UNITED STATES
DEPARTMENT OF THE INTERIOR
BUREAU OF LAND MANAGEMENT
Sundry Notices and Reports on Wells

8. **Well Name & Number**
Schlosser No. 101S

Re: Permanent Abandonment
Well: Schlosser 3 #101S

CONDITIONS OF APPROVAL

Proposed P&A

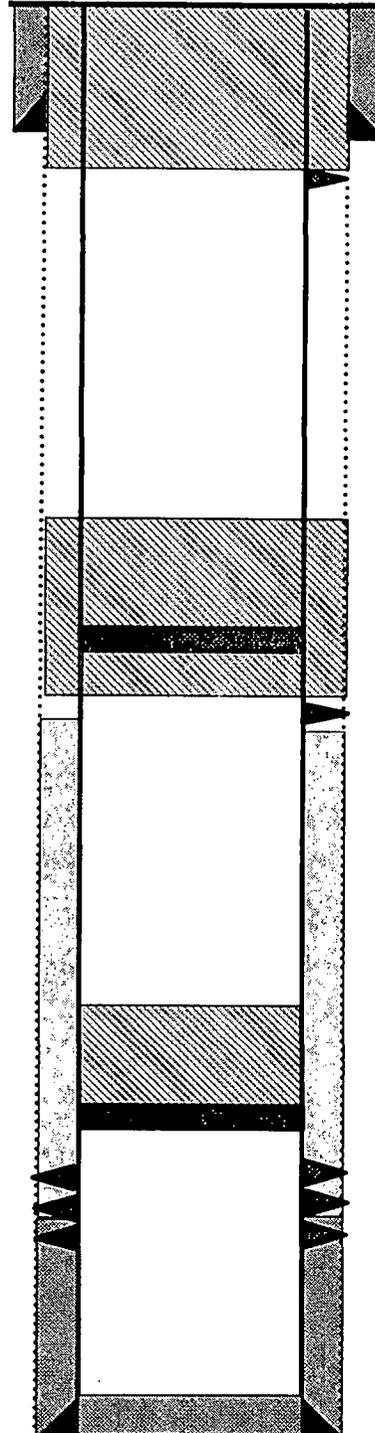
1. Plugging operations authorized are subject to the attached "General Requirements for Permanent Abandonment of Wells on Federal and Indian Leases."
2. Farmington Office is to be notified at least 24 hours before the plugging operations commence (505) 564-7750.
3. The following modifications to your plugging program are to be made:
 - a) Bring the top of plug # 1 to 1564 ft. to cover the Fruitland top. Adjust cement volume accordingly.

You are also required to place cement excesses per 4.2 and 4.4 of the attached General Requirements.
